**RE: Expansion of the Yosemite West Service Area to Serve the YNP – Nature Bridge
Campus – Mariposa County**

RE: 2018 Sanitary Survey of the Yosemite West Water System

SUBJECT: SANITARY SURVEY
YOSEMITE WEST WATER SYSTEM
SYSTEM NO. 2210924
MARIPOSA COUNTY

Photo 1; Wellhouse with Fire Resistant Foil

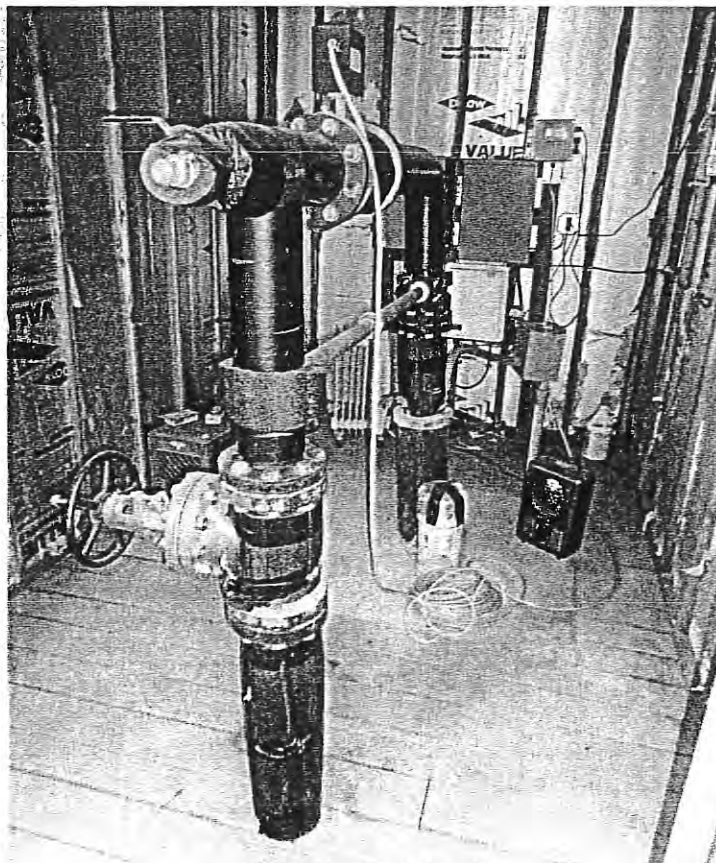
Well No. 9 is equipped with a 40-hp submersible pump set to a depth of 189 feet capable of producing between 85 gpm and 105 gpm. The well appurtenances include a casing vent that was downturned and screened. The well discharge piping includes a check valve, flow meter and sample tap. The well is housed in a small building that is kept locked at all times. Due to a recent forest fire that occurred prior to the site visit, the building was wrapped with a fireproof foil.
